CITY OF YPSILANTI
Planning Commission MEETING
Wednesday, July 20, 2022 @ 7:00 PM
Council Chambers
One South Huron, Ypsilanti, MI 48197

**Staff Review of Special Use and Limited Site Plan
300 W Michigan Ave**

Subject: Preliminary Site Plan Review Comments – 300 W Michigan Ave.

C-6

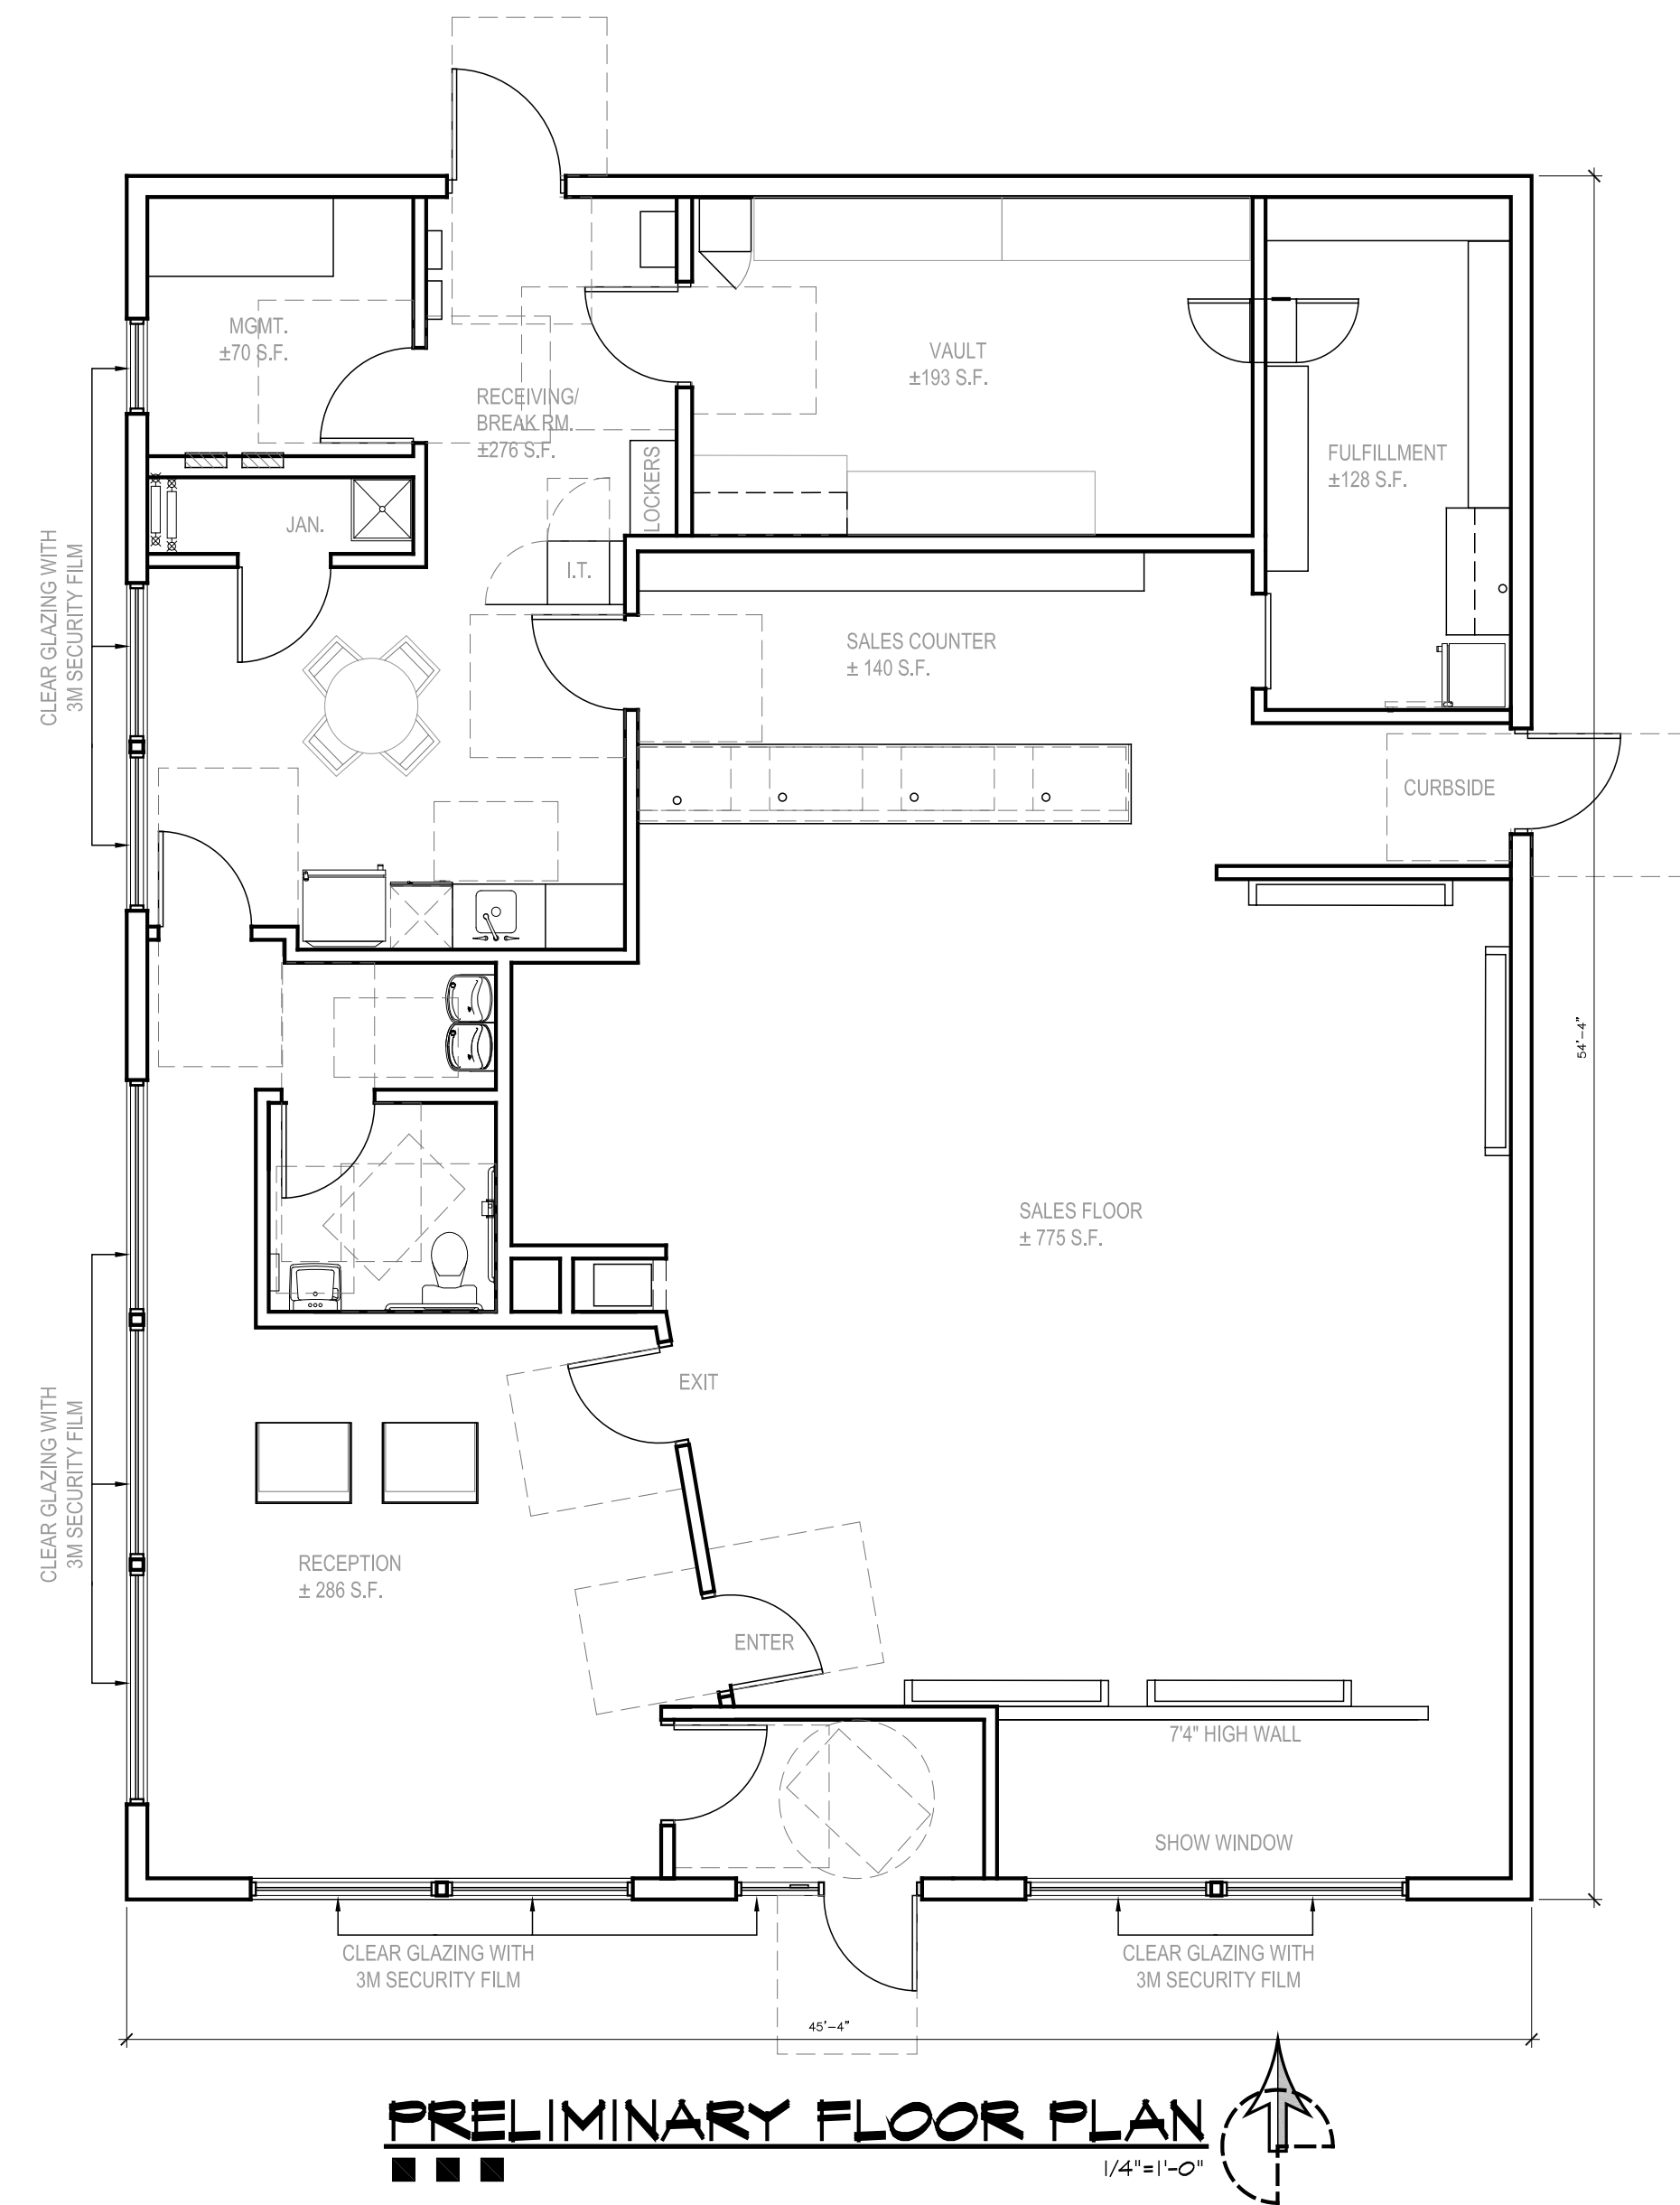
9. Applicant shall clarify where the Asphalt Pavement Rehabilitation detail on sheet C-6 is proposed in plan view. It is recommended the applicant consider other hot asphalt mixes for the wearing course.
